**NOTICE OF ADDENDUM
ADDENDUM NO. 1
City of Madison, Engineering Department**

**CONTRACT NO. 9359
Country Grove Park Shelter**

This addendum is issued to modify, explain or correct the original Drawings, Specifications, or Contract Documents marked as **Country Grove Park Shelter, City of Madison, Contract #9359, as issued on February 1, 2024** and is hereby made a part of the contract documents.

SHEET NUMBER:
C1.5

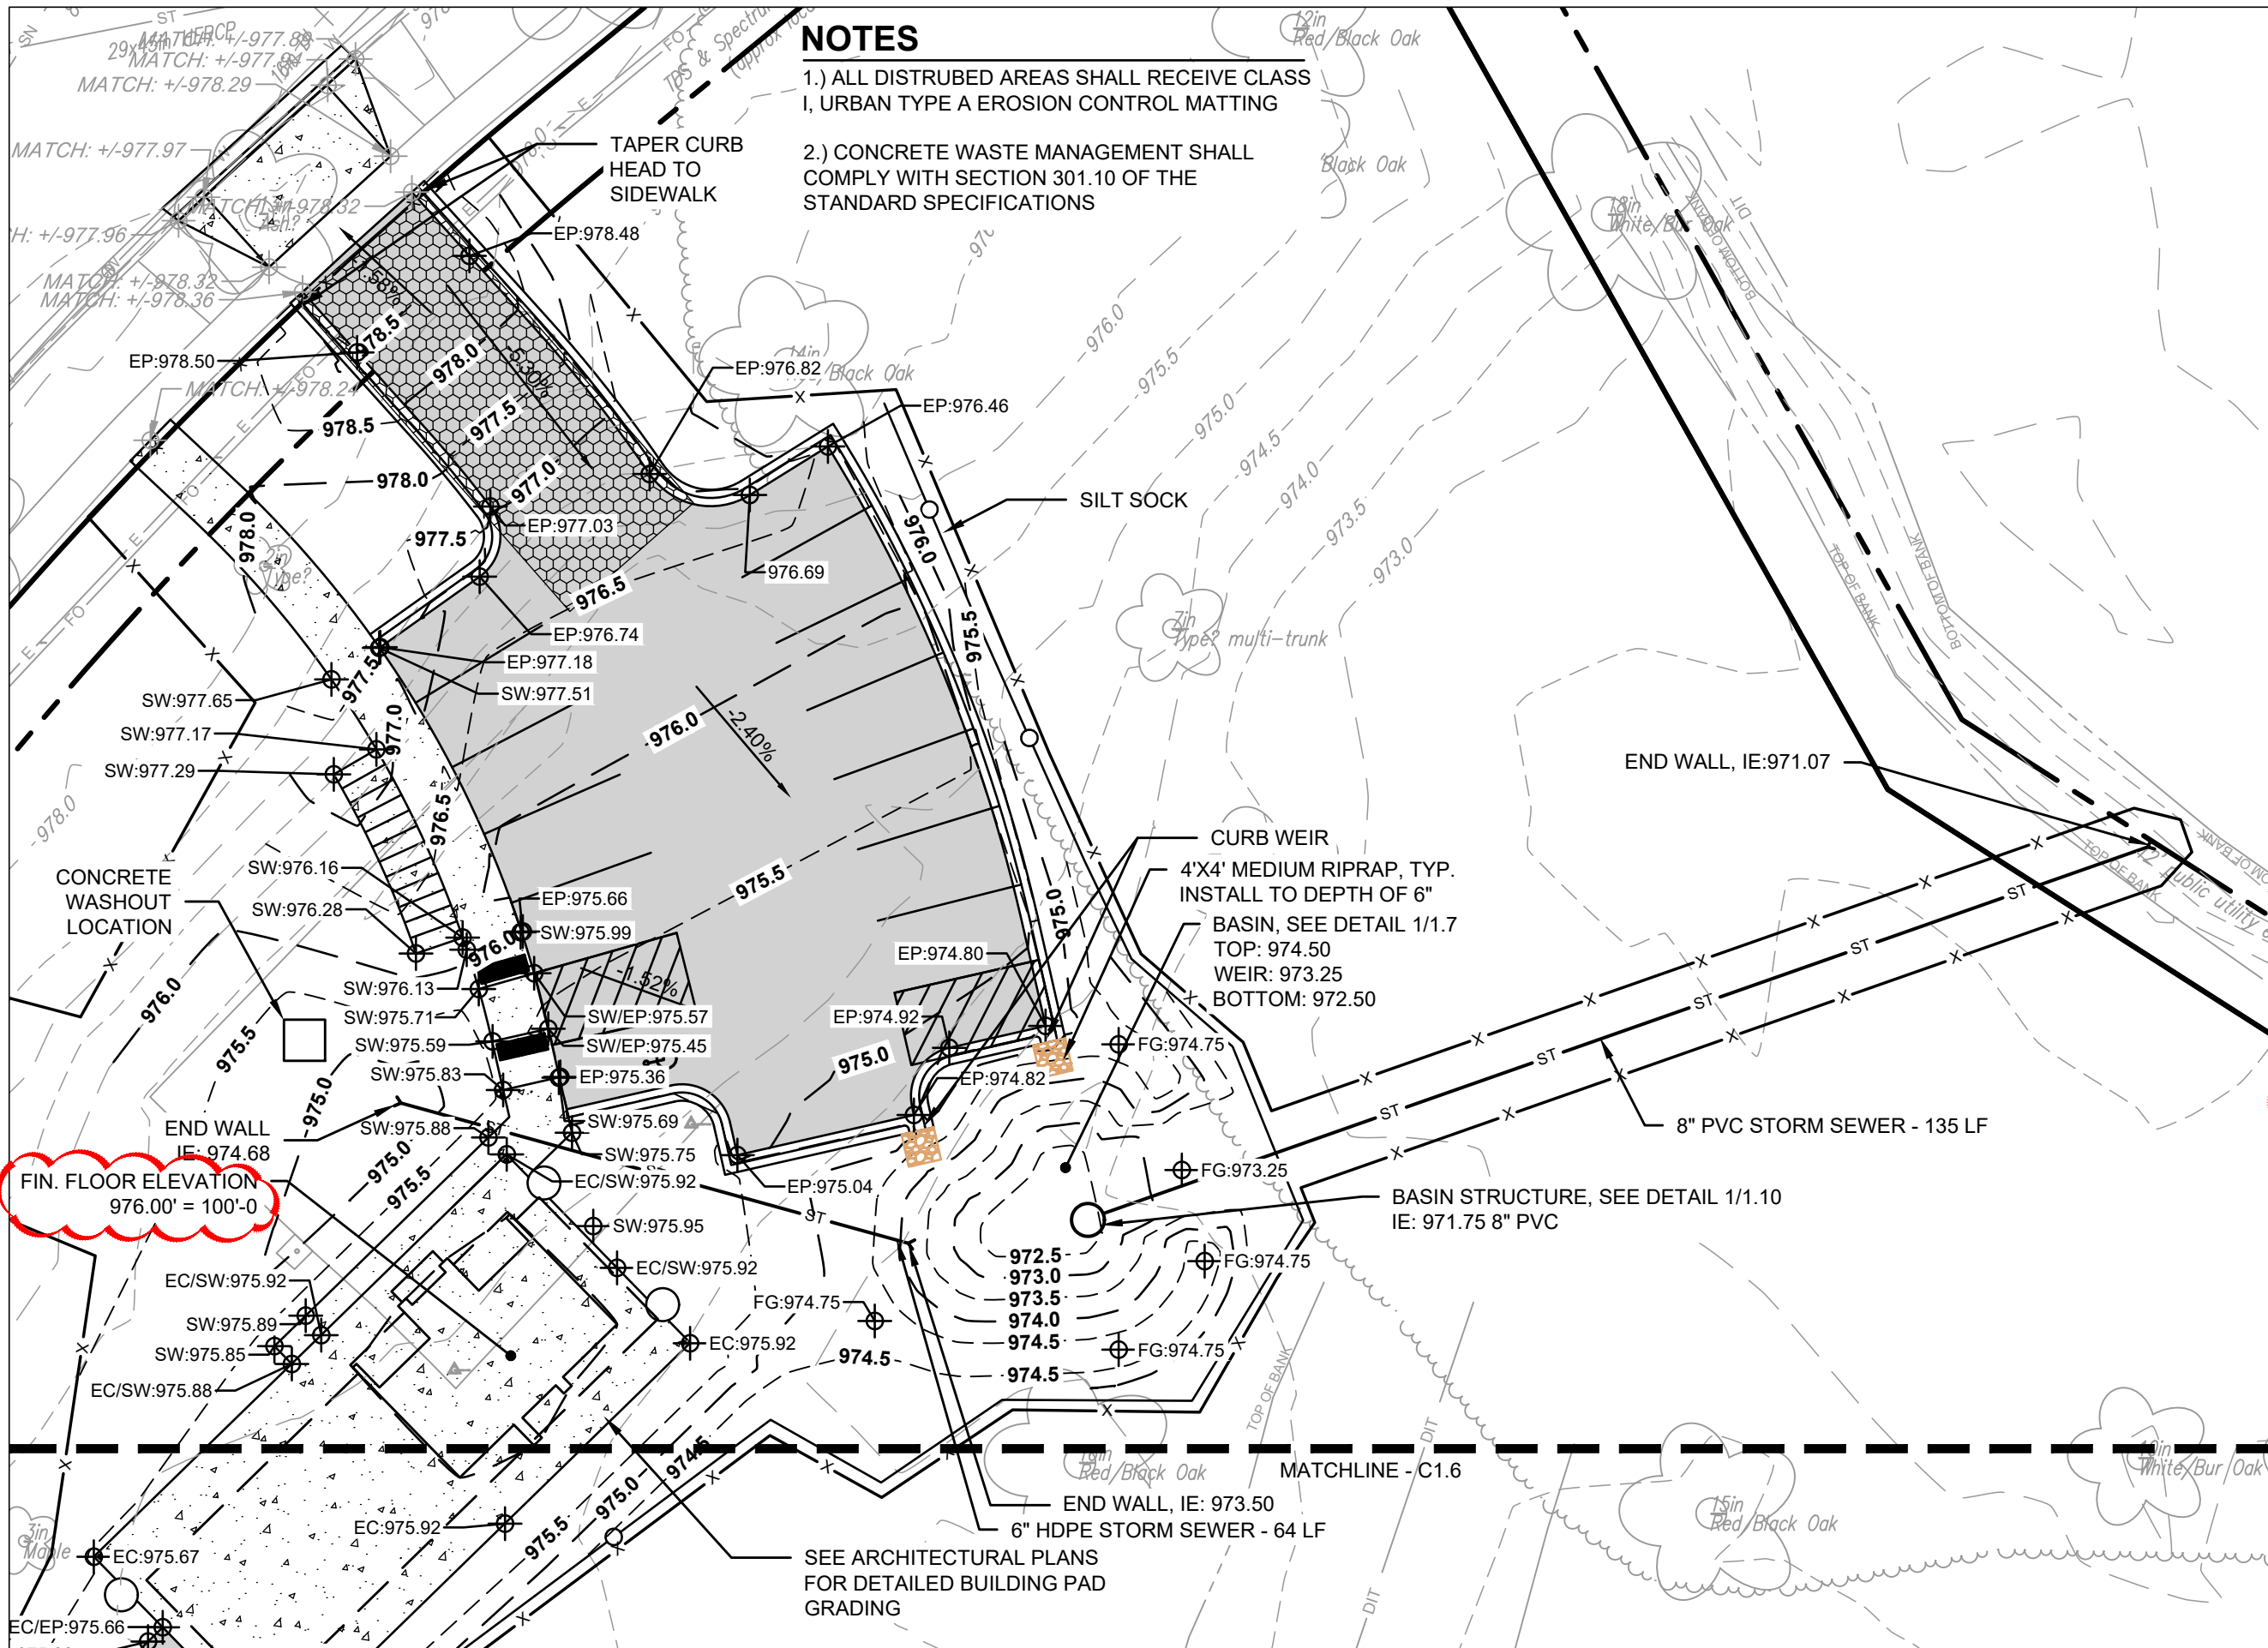
A5: Fin. Floor Elevation 976.00' = 100'-0" see attached drawing C1.5 & S100

- Drawing C1.5:** Replace with attached sheet.
 - Revise Building elevation “976.00” to read “Fin. Floor Elevation 976.00”.
- Drawing C2.3:** Replace with attached sheet.
 - Basin bottom area increased.
 - Basin bottom elevation changed to 973.50
 - Storm Sewer elevations revised.
 - Revised lengths of Construction Fence and Silt Sock.
- Drawing C2.4:** Replace with attached sheet.
 - Revised seeding areas
- Drawing C2.6:** Replace with attached sheet.
 - Basin bottom elevation changed to 973.50
 - Basin storm structure revised.
- Drawing C2.7:** Replace with attached sheet.
 - Changed IE to 973.00
 - Changed standpipes to one 4” and one 6”
 - Changed structure height to 1’-6”
 - Added sawcut “V” to structure

C2.6

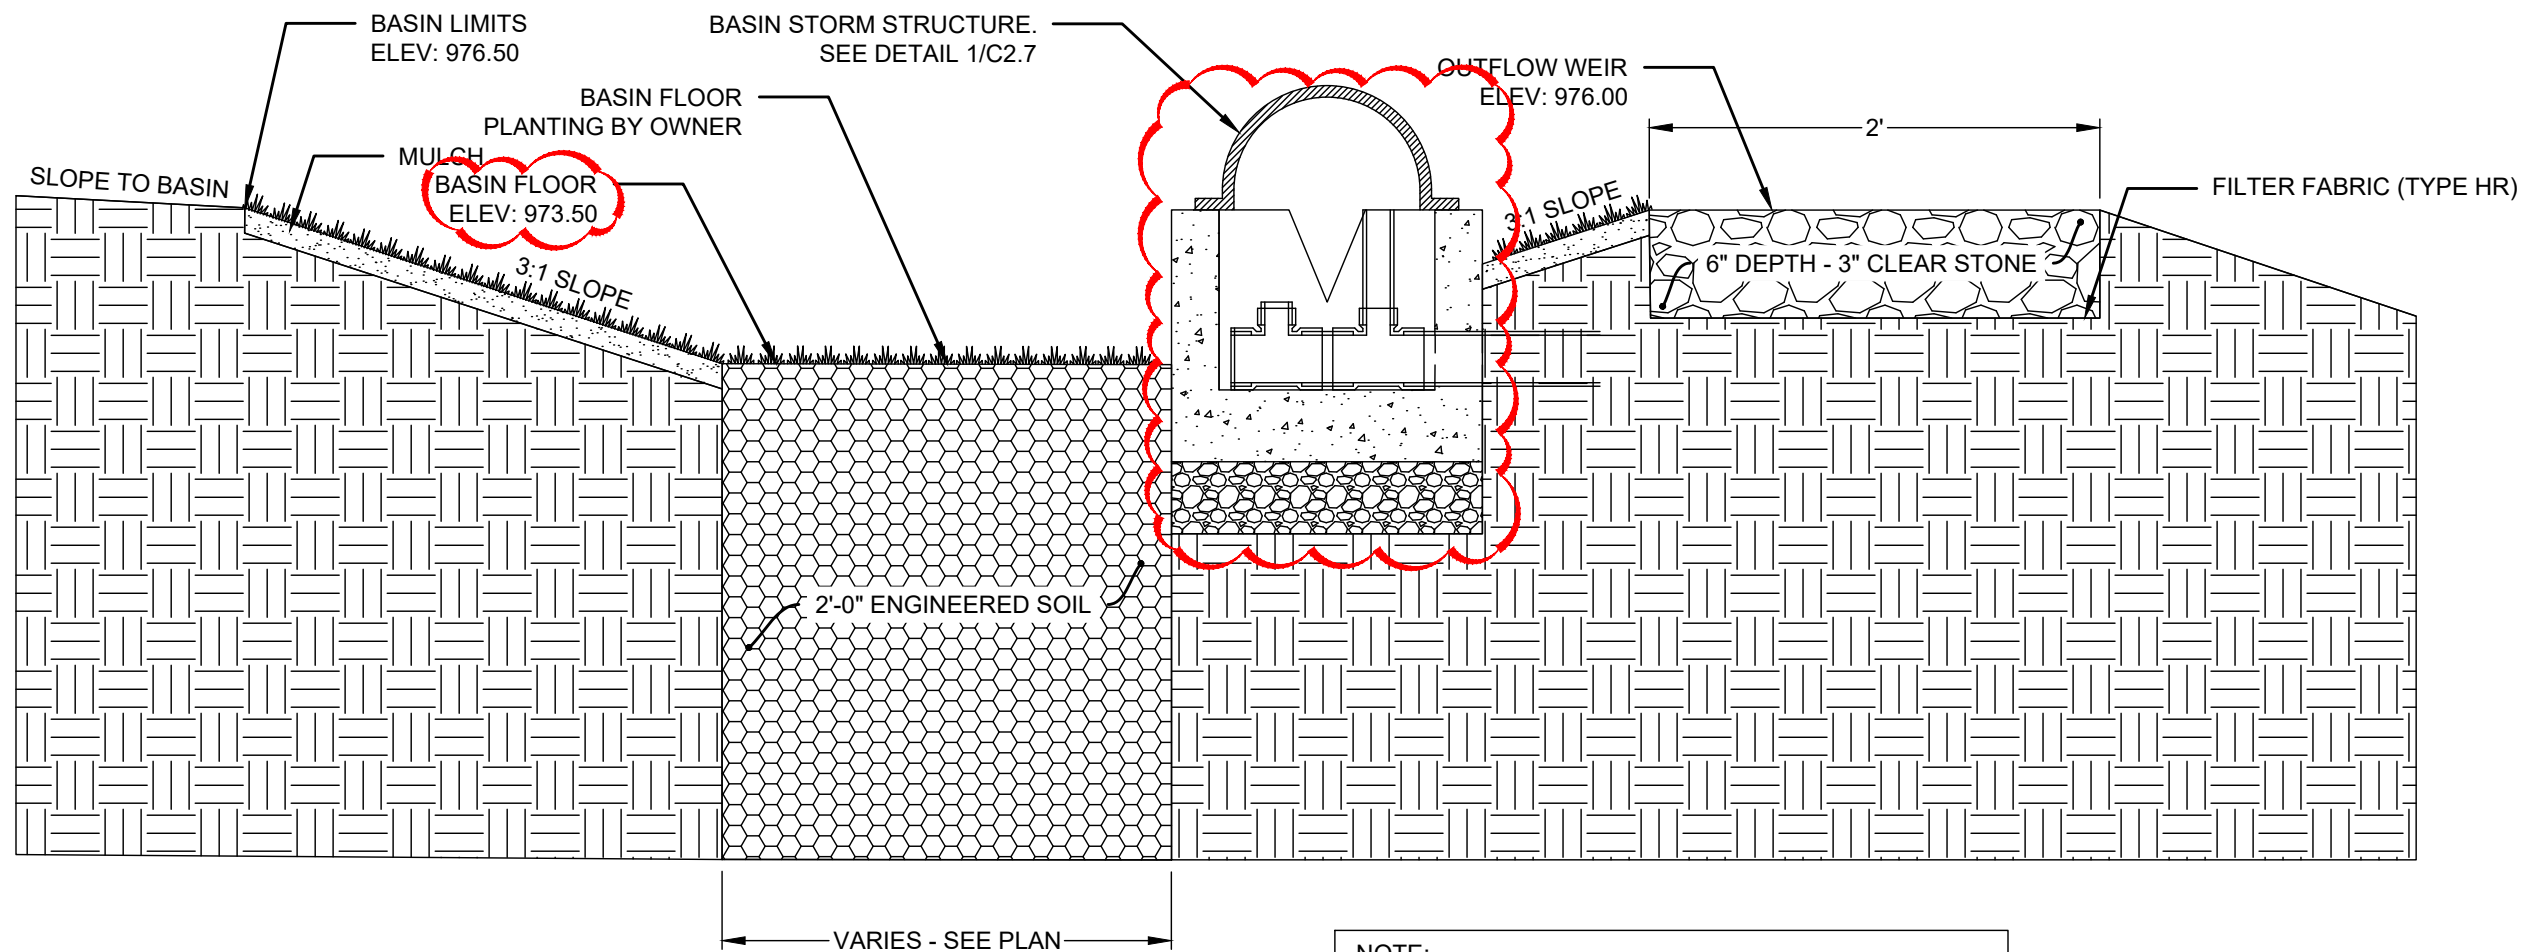
- D. Q4: Drawing C2.6 - Please clarify how deep the engineered soil goes.

A4: The engineered soil goes 2' below the bottom elevation of the basin. Based on soil borings performed, we expect the bottom elevation of the engineered soil to infiltrate into the native sand soil layer.

1 SITE UTILITY PLAN
 SCALE: 1" = 30'-0"
 0 10' 20' 30' 50' 100'

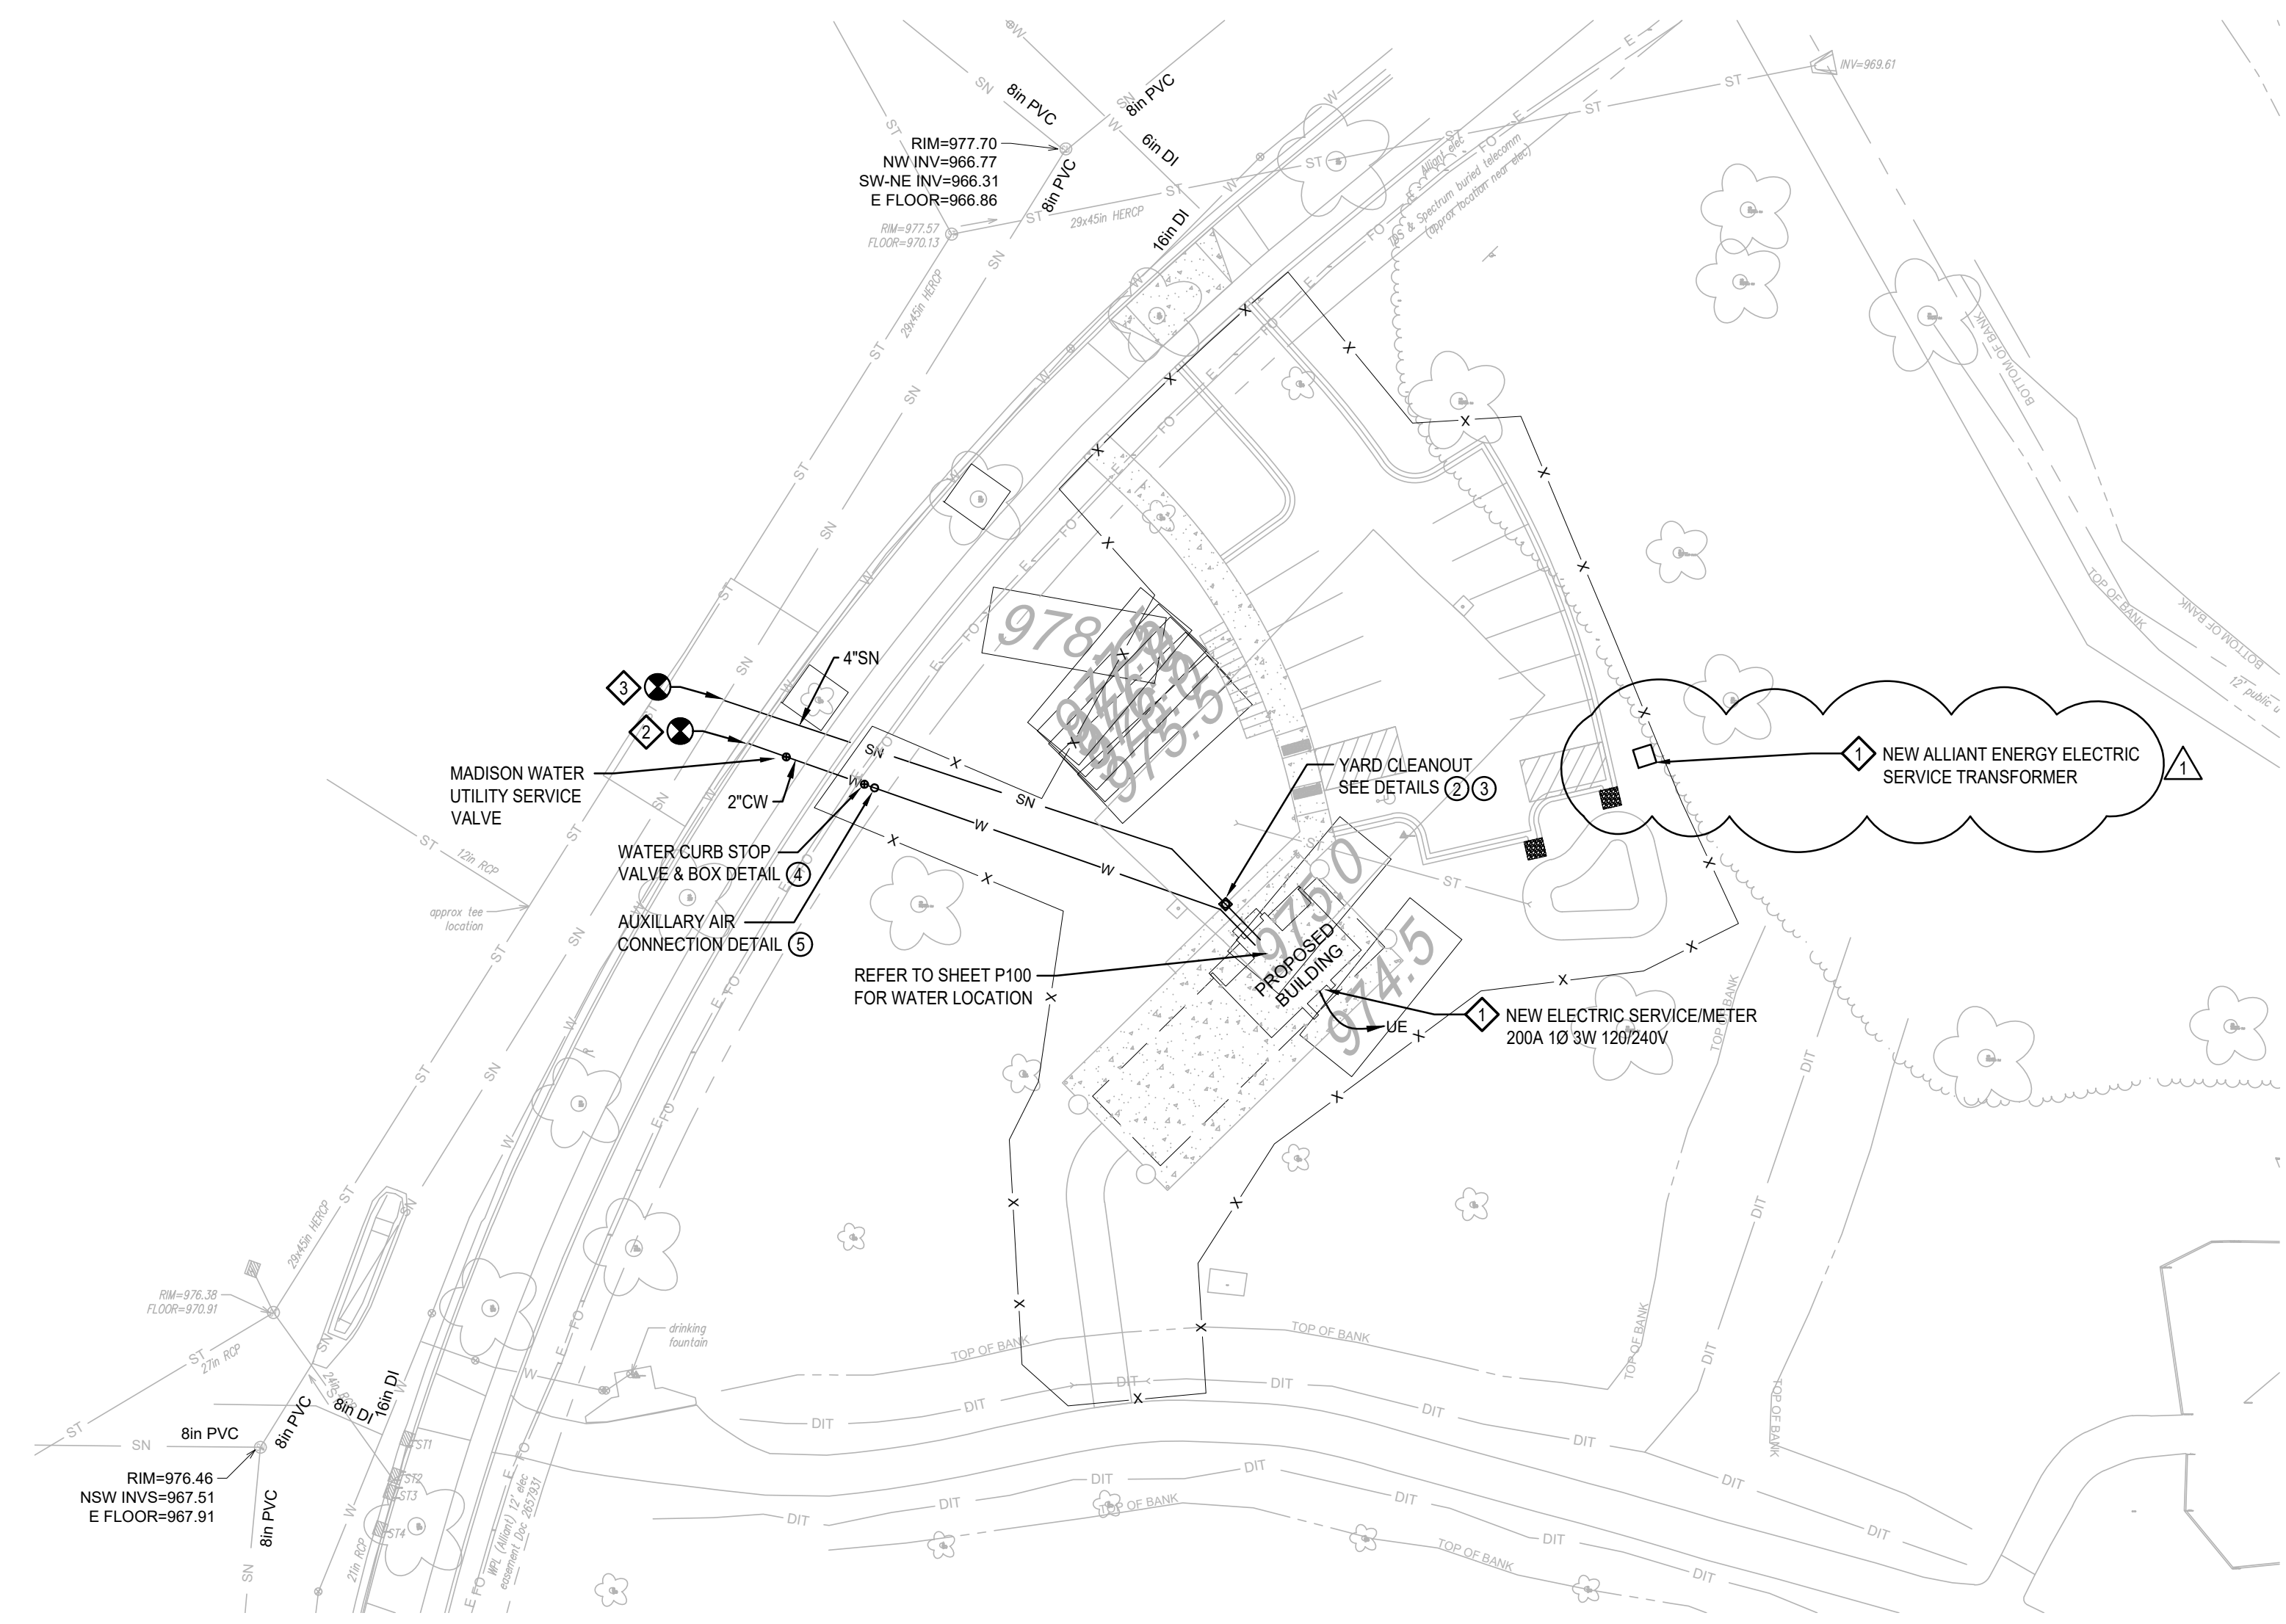
- Drawing C100:** Replace with attached sheet.
 - Clarification on proposed new Alliant Energy utility transformer location and electrical service into the park.
